Aircraft Restoration Corporation

# SERVICE BULLETIN

NO. ARC-SB-852-011

Inspection of the MLG Uplock Hook alignment and installation of a large area bushing on the uplock roller assembly.

**Figure 1, Uplock Hook and Roller Alignment.**

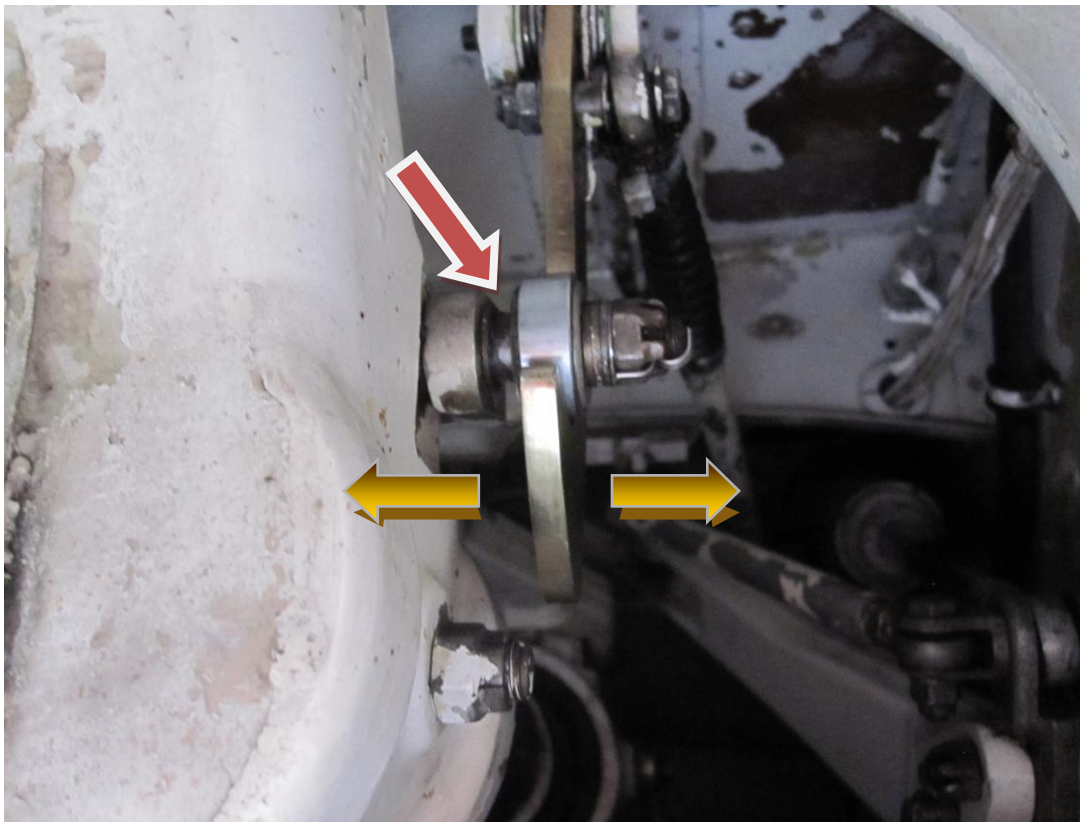
Place the airplane on jacks. With the landing gear down and locked, measure the side to side movement of the uplock hooks, it should be less than .150 inch total side to side movement. (Reference gold arrows Figure 1 below). If it is loose,

As an added safety measure, remove the small area bushing spacer, Piper P/N: 14175-06, from the inside of the uplock roller (Reference red arrow Figure 1 below) install one large area bushing spacer, Piper P/N: 41413-79 or ARC P/N: 85280129-00, in its place. Re-check the hook to roller alignment with the landing gear retracted.

Retract the landing gear to check that the uplock hook centers on the uplock roller. Perform a landing gear function test. Rig the landing gear in accordance with the instructions in the appropriate Navajo or Cheyenne Service Manual. With the landing gear down and locked remove the airplane from the jacks. Complete a log book entry showing that this S/B has been complied with.
